# CITY OF ALBUQUERQUE

RE: **El Manzanal Subdivision** - 704 Griegos Road, NW  
**Conceptual Grading & Drainage Plan**  
**Engineer's Stamp Date (none) (File: F14D069)**

Sheet Title:  
**PRELIMINARY  
GRADING AND  
DRAINAGE PLAN**

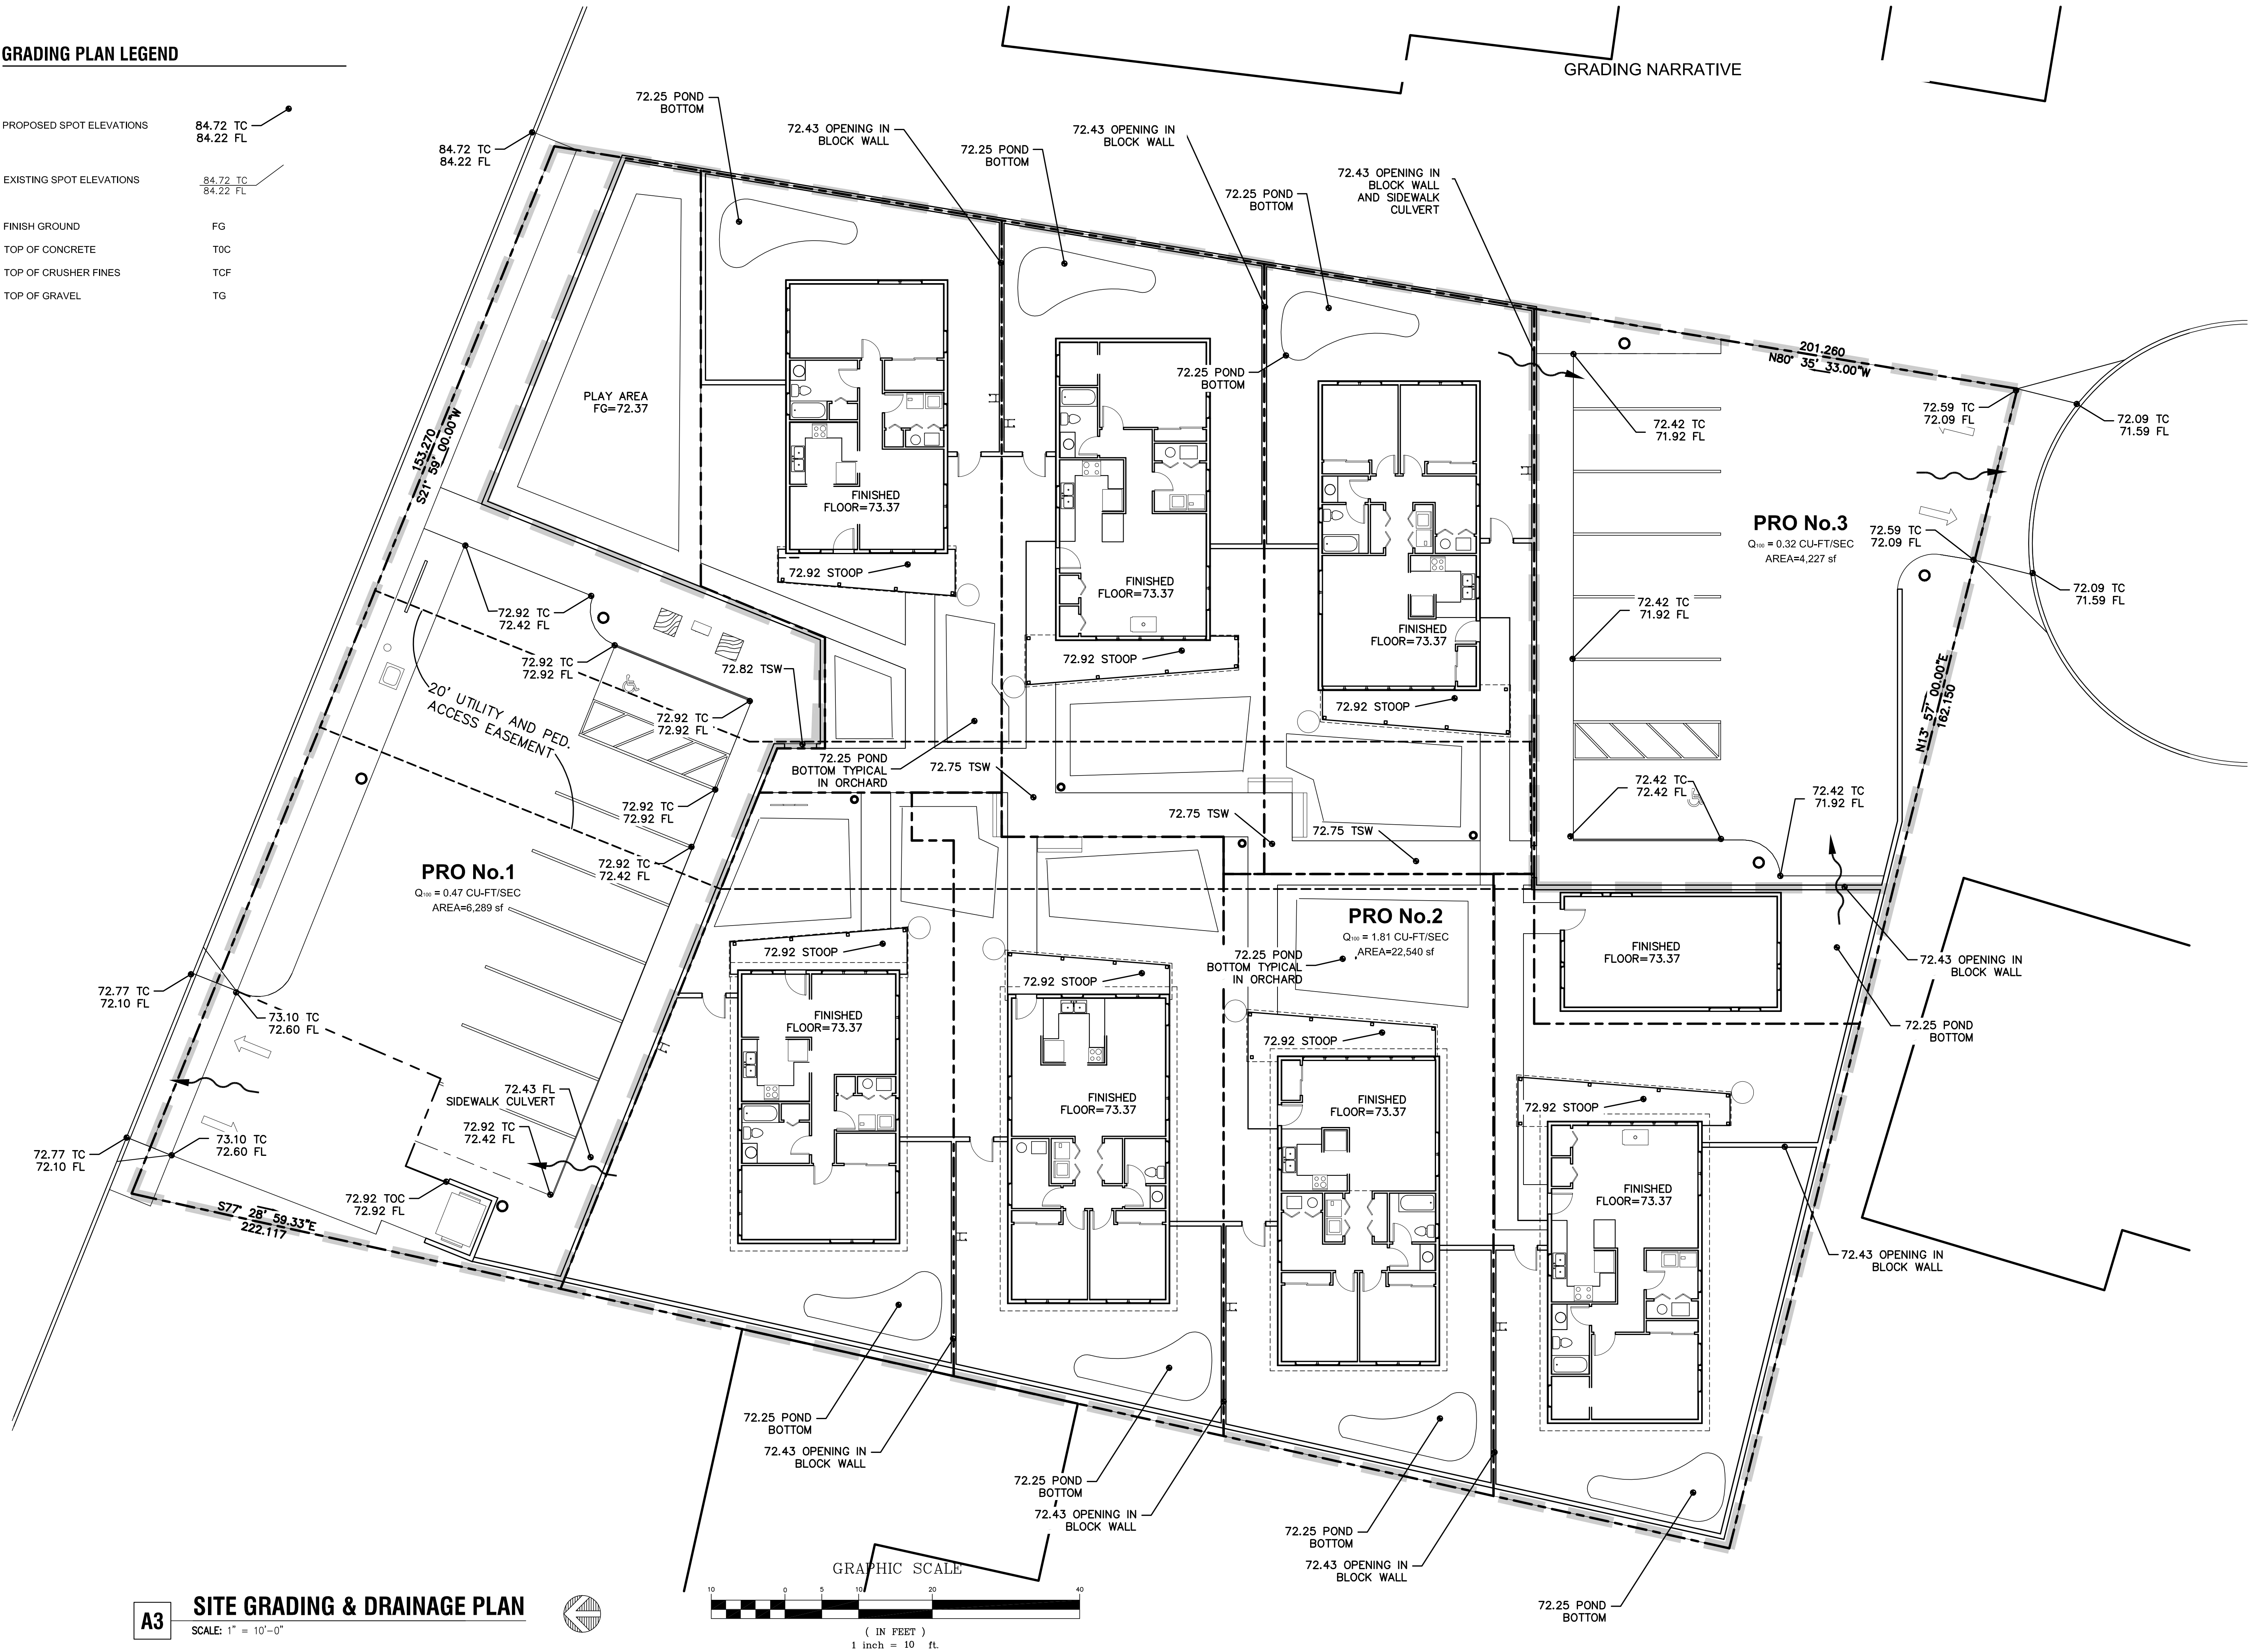
1. Show existing spot elevations/ contours on site and adjacent to property
2. State how the first flush is to be managed.
